RHODE ISLAND DEPARTMENT OF TRANSPORTATION

RHODE ISLAND CONTRACT NO.2013-CB-080

Kent Dam Spillway Bridge No. 84 & Scituate Ave 1R

NOTICE TO PROSPECTIVE BIDDERS

GENERAL PLAN NO. 1

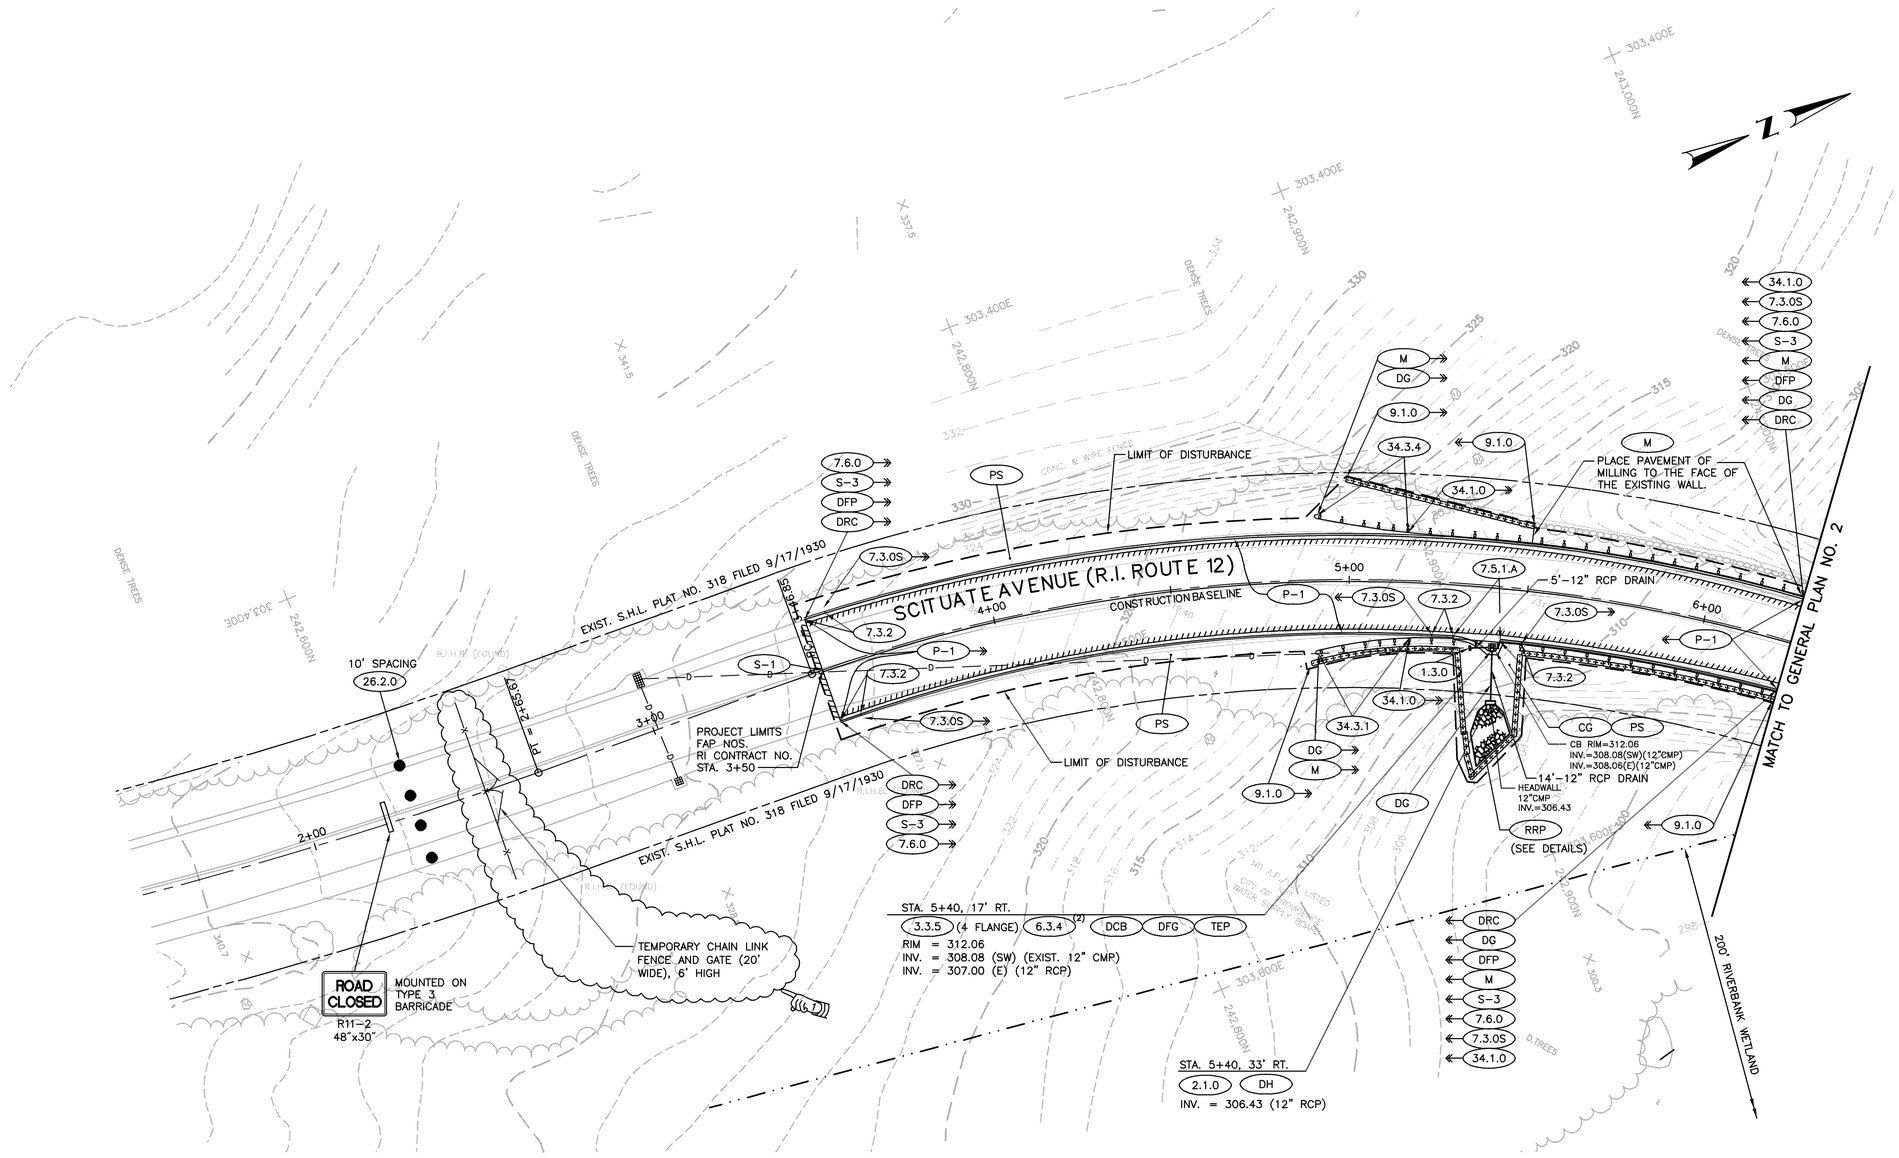
Remove Sheet No. 9 in its entirety and replace it with revised Sheet No. 9 (R-1) attached to this Addendum No. 1. The Temporary Chain Link Fence and Gate have been added.

GENERAL PLAN NO. 2

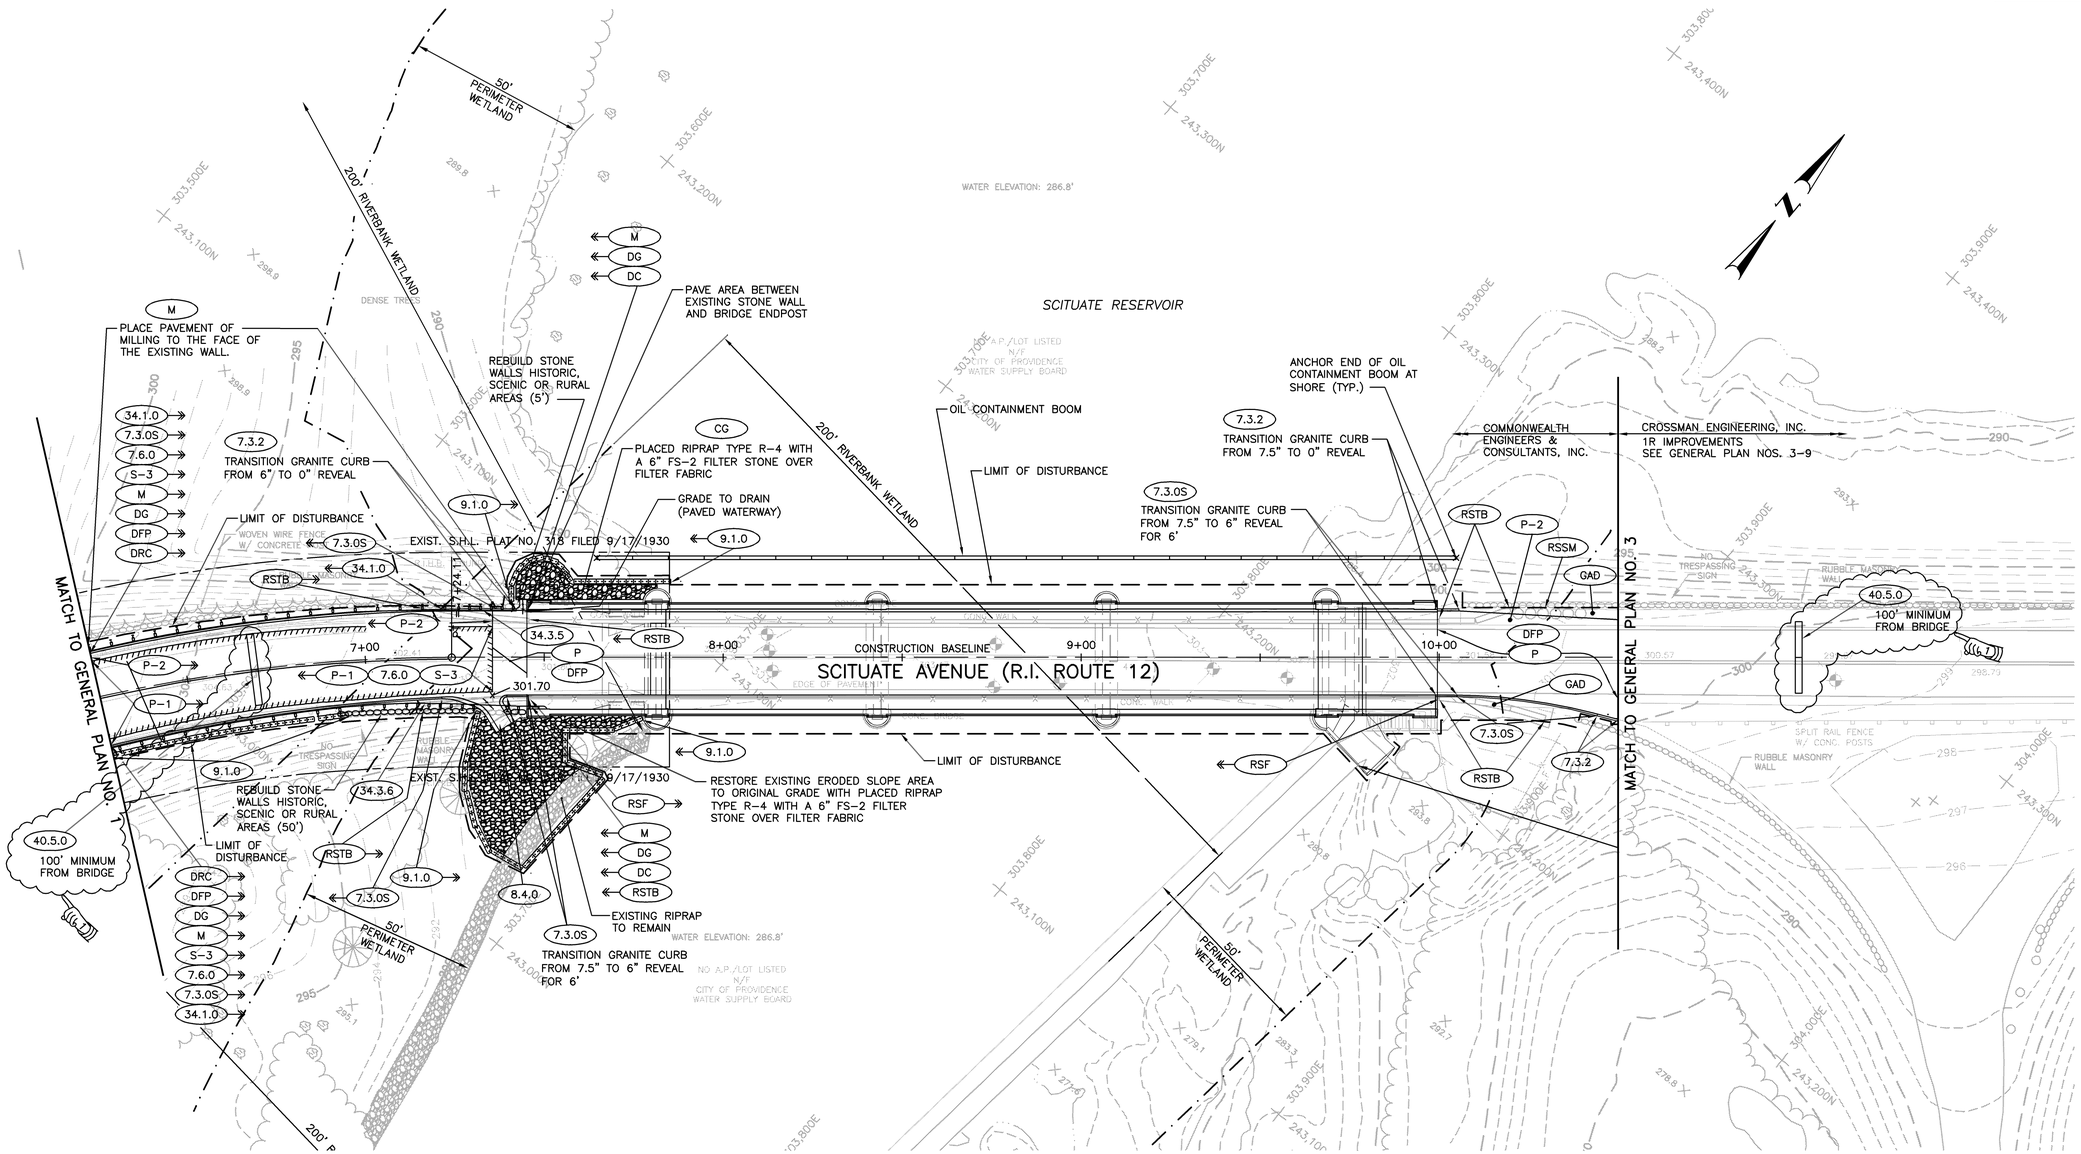
Remove Sheet No. 10 in its entirety and replace it with revised Sheet No. 10 (R-1) attached to this Addendum No. 1. The Precast Median Barriers for Temporary Traffic Control have been added.

GENERAL PLAN No. 8

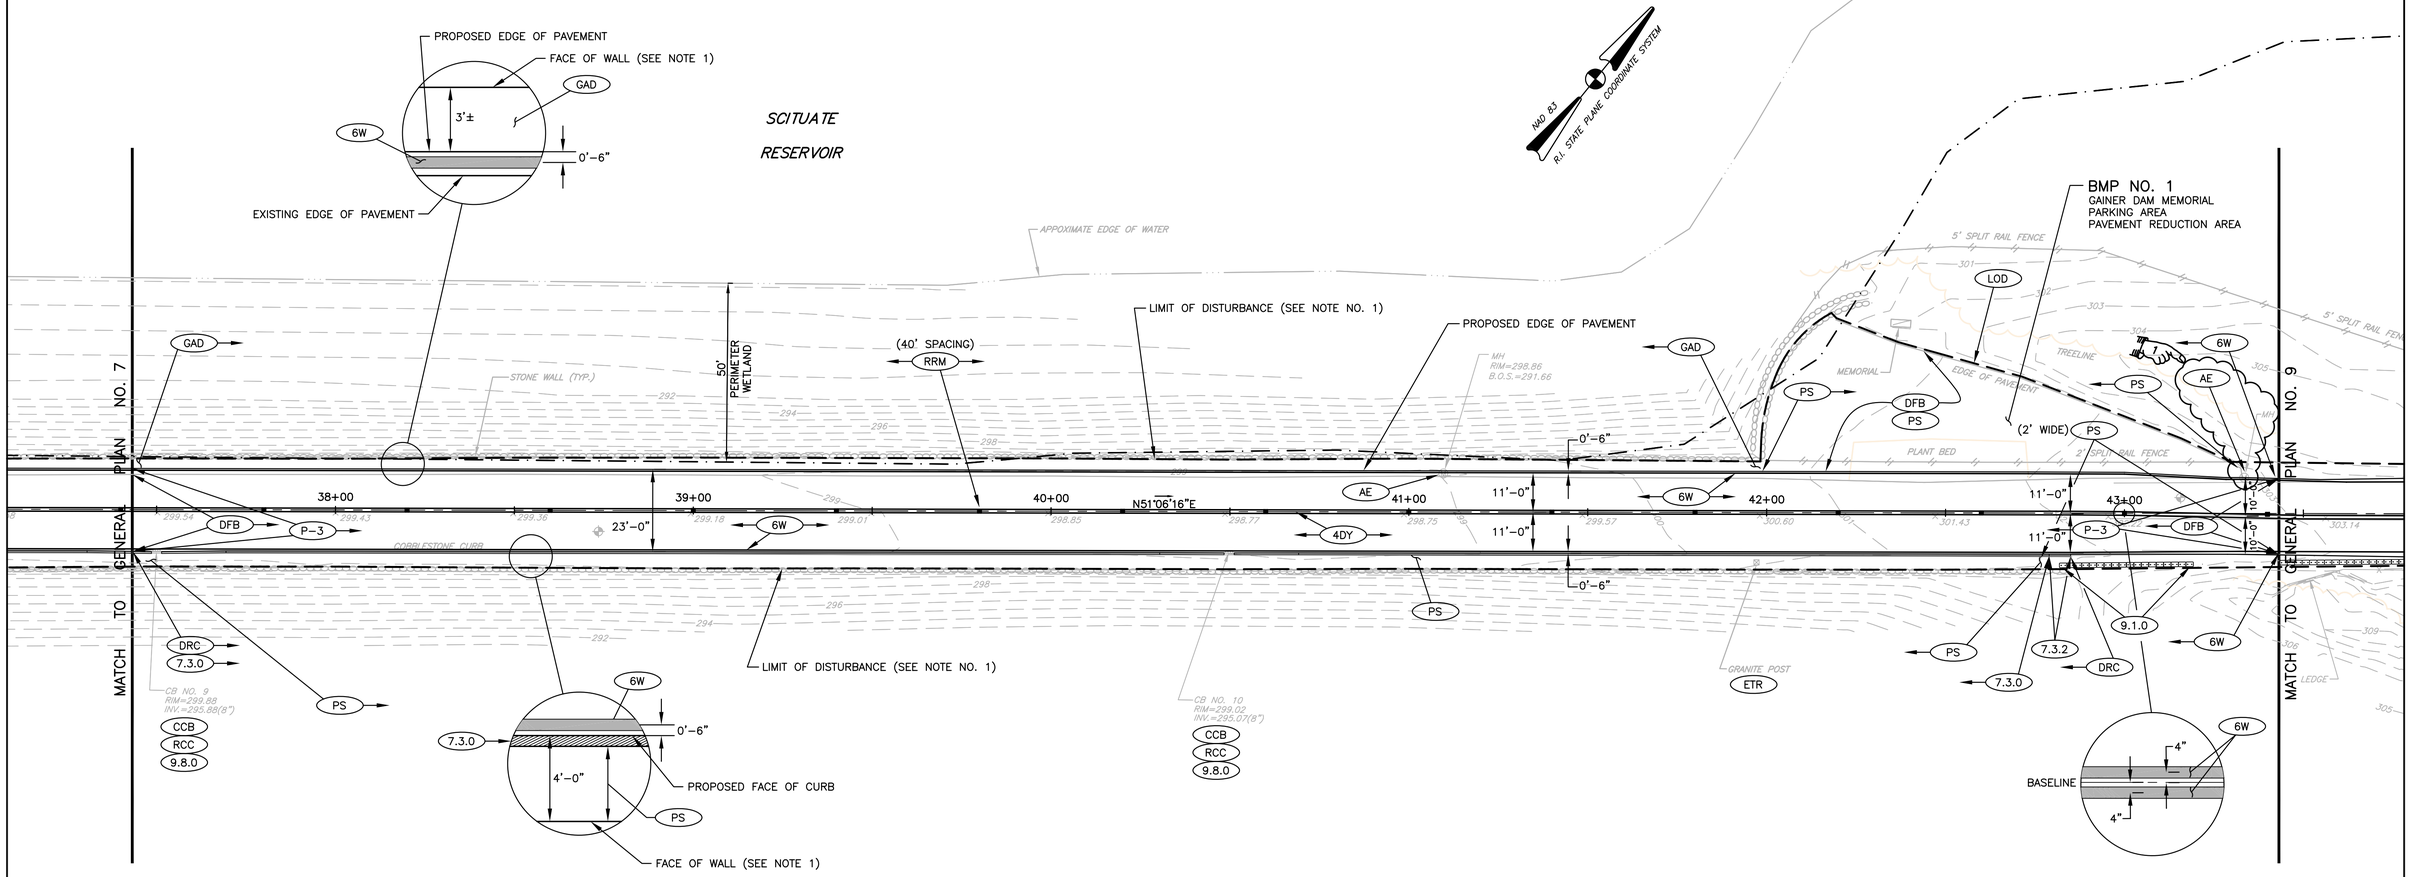
Remove Sheet No. 16 in its entirety and replace it with revised Sheet No. 16 (R-1) attached to this Addendum No. 1. An existing manhole and associated call-out have been added.

GENERAL PLAN No. 9

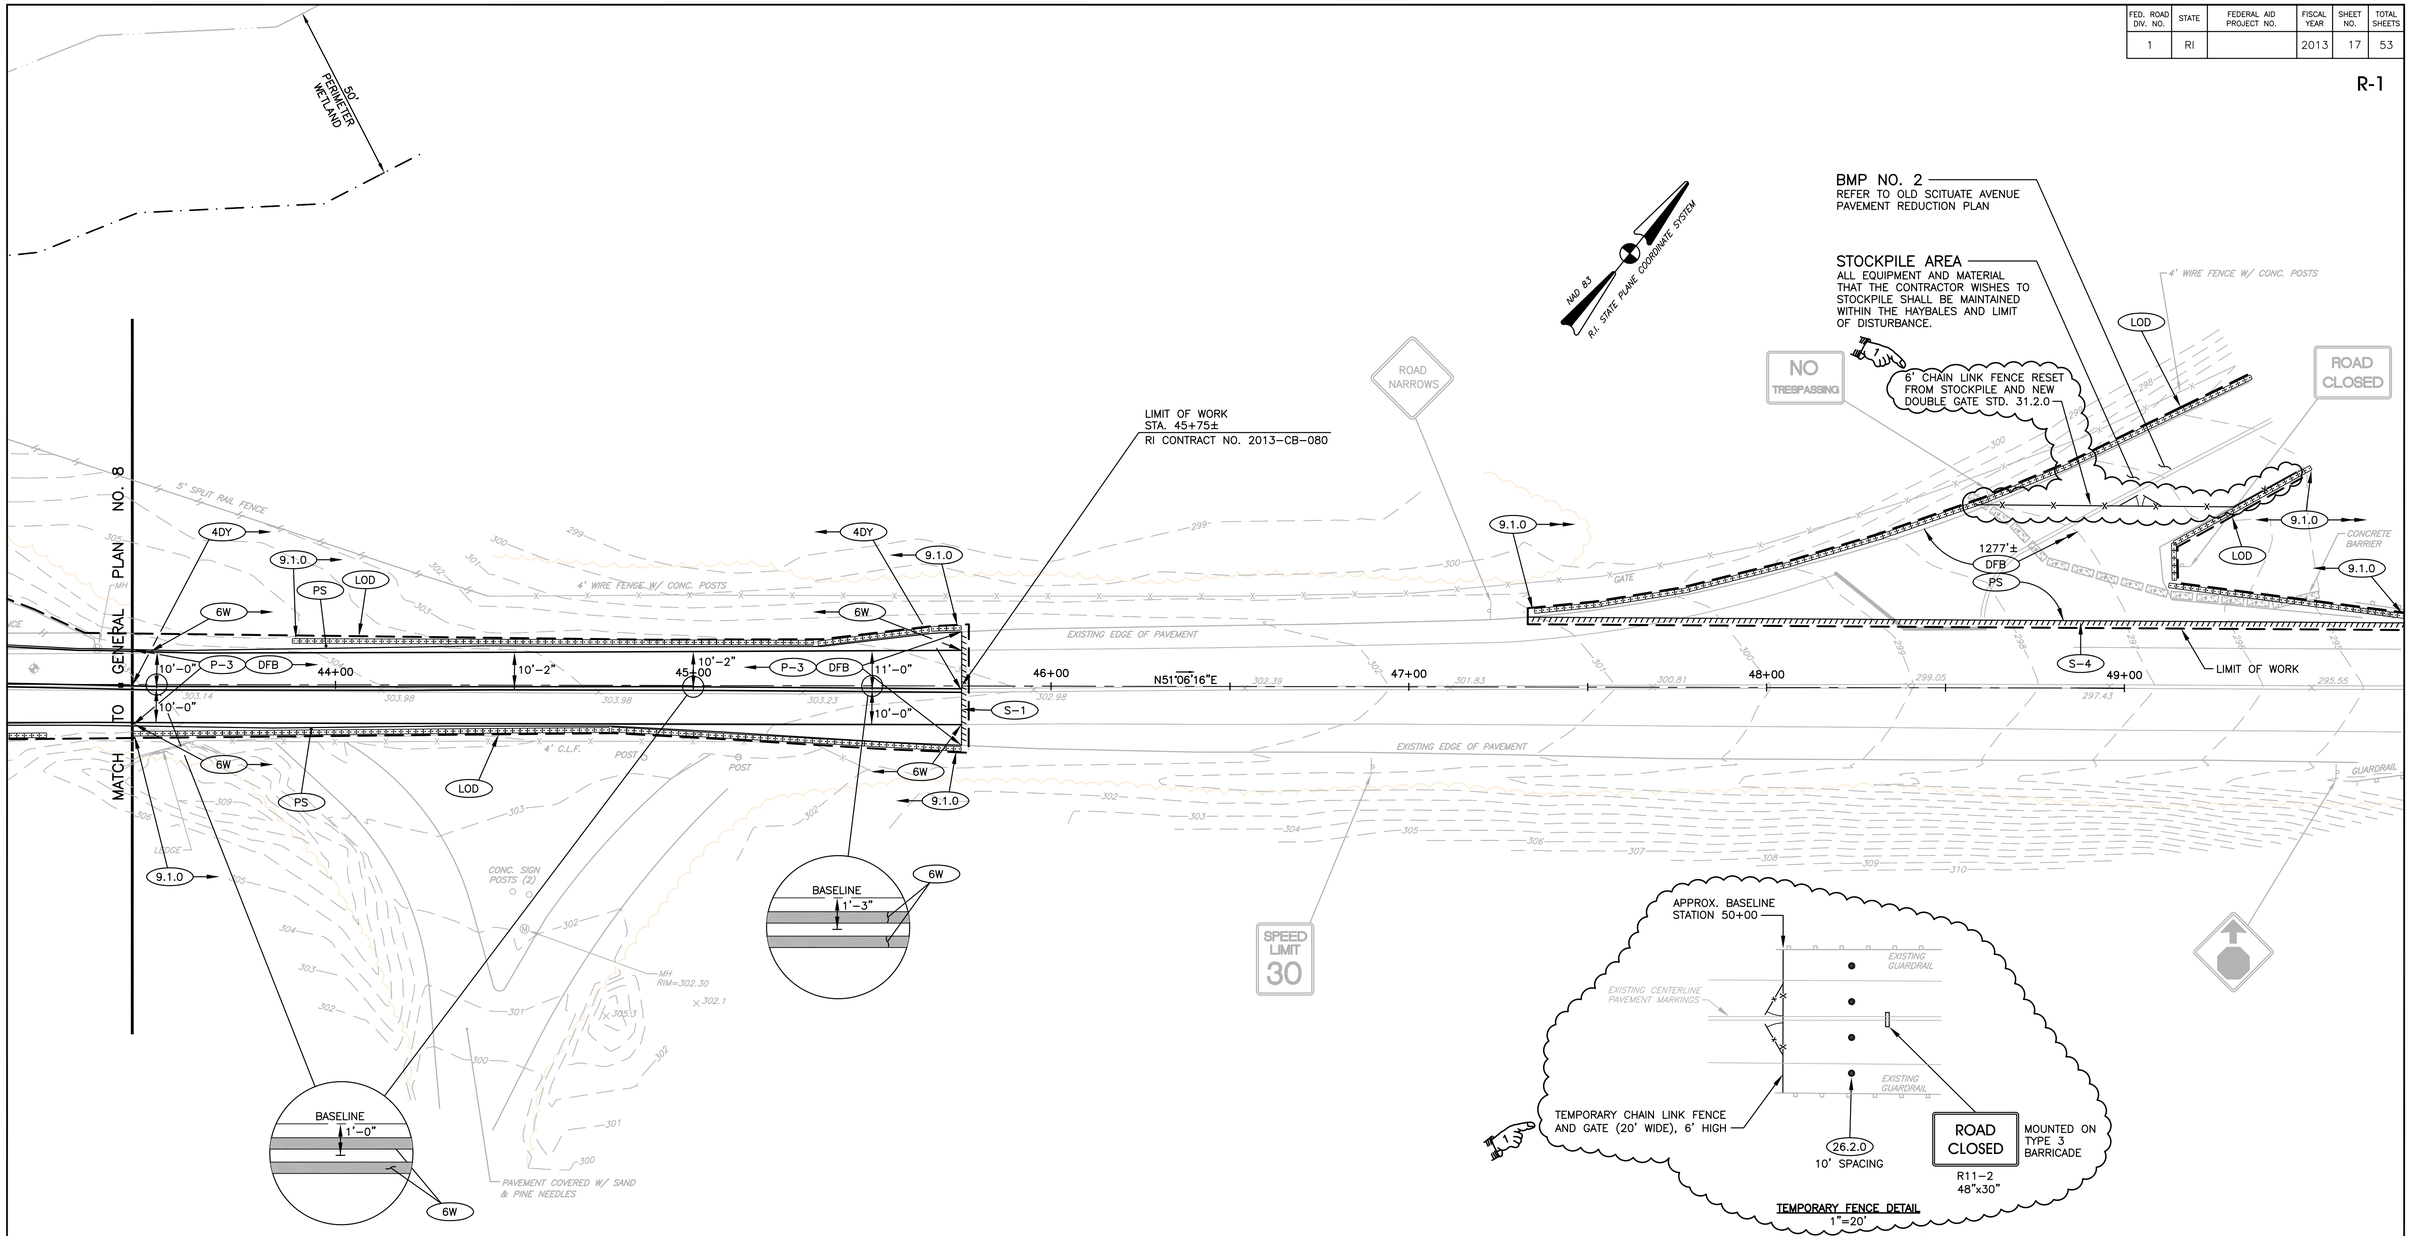
Remove Sheet No. 17 in its entirety and replace it with revised Sheet No. 17 (R-1) attached to this Addendum No. 1. The Temporary Chain Link Fence and Gate and the 6' Chain Link Fence Reset From Stockpile have been added.
